**AERONAUTICAL CHARTING FORUM**  
**Instrument Procedures Group**  
**April 27, 2010**  
**HISTORY RECORD**

**FAA Control # 10-01-292**

**Subject: Removal of the Visual Climb Over Airport Option on Mountain Airport Obstacle Departure Procedures.**

GYPSUM FOUR DEPARTURE (OBSTACLE) EAGLE, COLORADO  
(GYPSM4.RLG) 09239 EAGLE COUNTY RGNL (EGE)

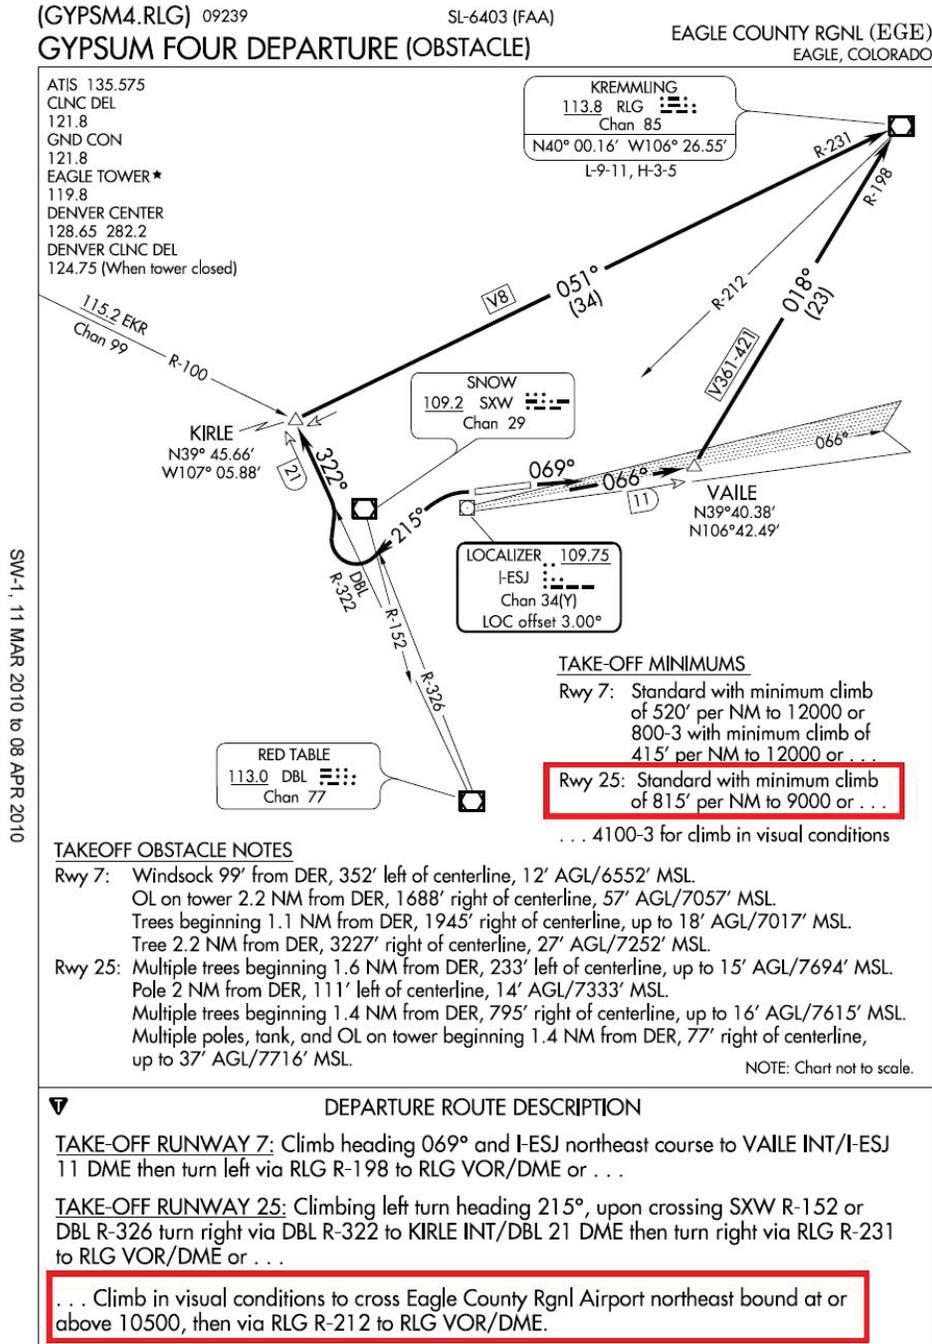
The ODPs in question (Figure 1 & 2: EGE – GYPSM Four & ASE – SARDD One) have higher than standard climb gradients that are difficult, if not impossible for many single & multiengine piston, single & multiengine turboprop, and even some multiengine turbojet airplanes to achieve in some weather/density altitude conditions. If the higher than standard climb gradient published for the runway/departure route cannot be achieved, the removal of the VCOA option may prevent an airplane from departing these airports in IFR conditions if the operation is conducted under 14 CFR part 135, reference 14 CFR 91.175 (f)(3):

The climb rate required to depart EGE's runway 25 using the GYPSM Graphic ODP can easily exceed 1600 ft/min for many multiengine piston and turboprop airplanes. While the climb required to depart ASE's runway 33 using the SARDD ODP is not as great (900 ft/min), the altitude to which the climb must be continued, 14,500 ft MSL, is equally imposing.

NBAA requests that the NOTAMS affecting the ODP's at Aspen, CO and Eagle, CO be amended to restore the option for the pilot to use the VCOA and that the NOTAMS impose a requirement that the pilot advise ATC prior to departure of their intentions to depart the airport IFR using the VCOA. This advisory should also be included in the ATIS broadcast when weather conditions warrant.
